Conceptual Review Agenda

Schedule for 08/31/15 to 08/31/15

1603 & 1605 N College Ave Drive-Thru Restaurant

Re: 1603 & 1605 N College Ave - Drive-Thru Restaurant

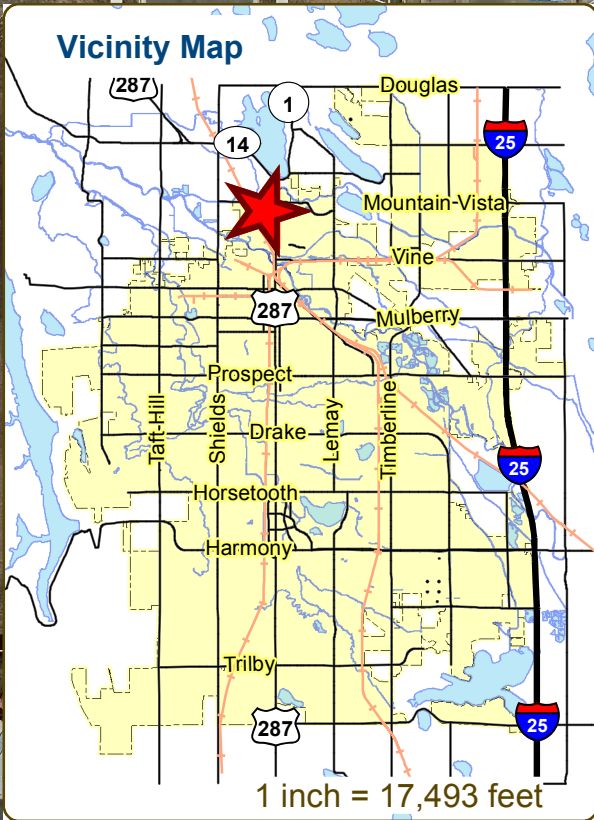
4. Please provide building dimensions on the proposed building on the site plan.
5. The proposed project is in the less restrictive sign district however please note that LUC 3.8.7(G)(9) restricts a menu board to one only with a single face and no more than 35 s.f. in size and 5' overall height max. Signage is regulated by a separate permit and is not considered part of the Project Development Plan.

The proposed site plan fails to comply with this standard. Placing commercial buildings along streets such that the building fronts the street versus vehicular use areas is a primary

2. Per the conceptual site plan, there is a parking lot and drive-through lane located between North College Avenue and the proposed building. This is in violation of one of the Land Use Code's most fundamental site planning standards. The standard, Section 3.5.3(B) states:

The proposed site plan fails to comply with this standard and should be re-designed accordingly.

3. The drive-through lane, the menu board, the pick-up windows and headlight glare are all elements of the site plan that are considered to be areas of low visual interest and yet they are all located in such a way as to highly visible to the adjoining property to the south. Screening will also be required along the west property line for the benefit of the existing residences. Should the site plan be re-designed, please note that these site plan elements must be screened so as to not have a negative impact on the adjoining properties.
4. While the Conceptual Review application does not indicate a potential end-user, please note that the Land Use Code contains an important standard, Section 3.5.3(E) – Character and Image. This standard states:

SHEET NO.
A1.02

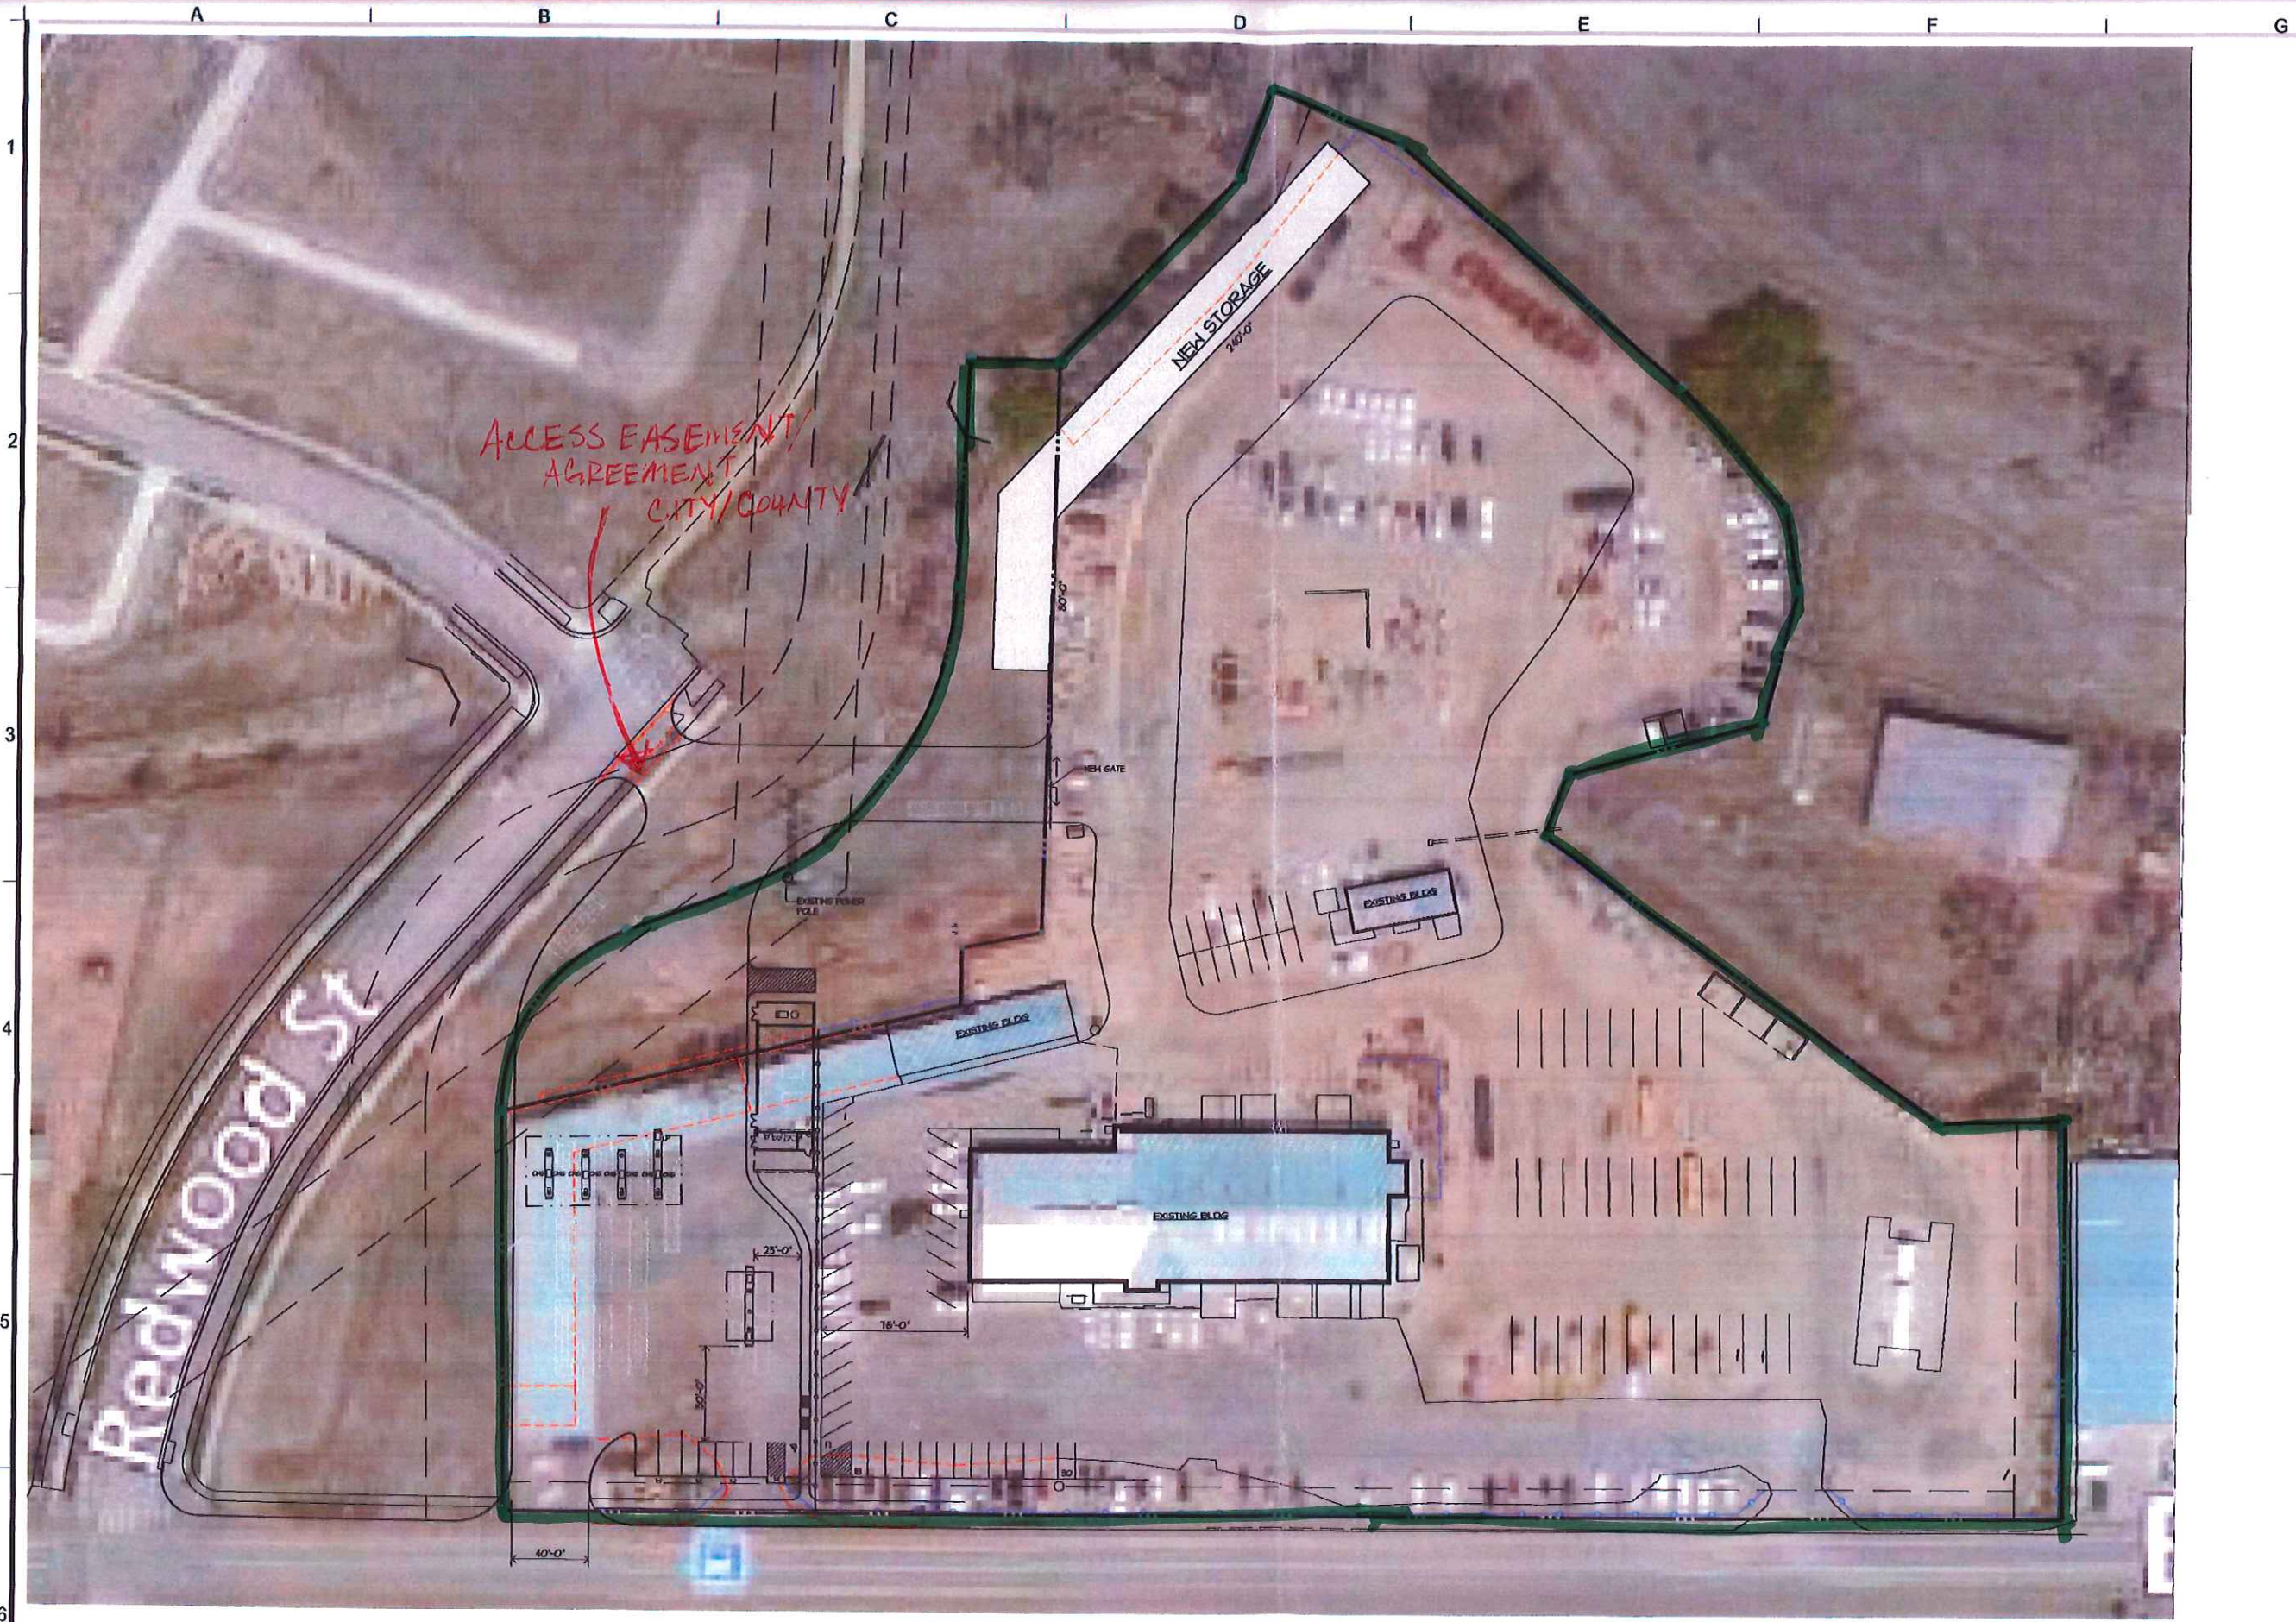
7. The area labeled "new storage" on the conceptual plan is not likely to be an acceptable use within the buffer zone for the adjacent ditch. The limits of the buffer zone will be determined based on the Ecological Characterization Study.
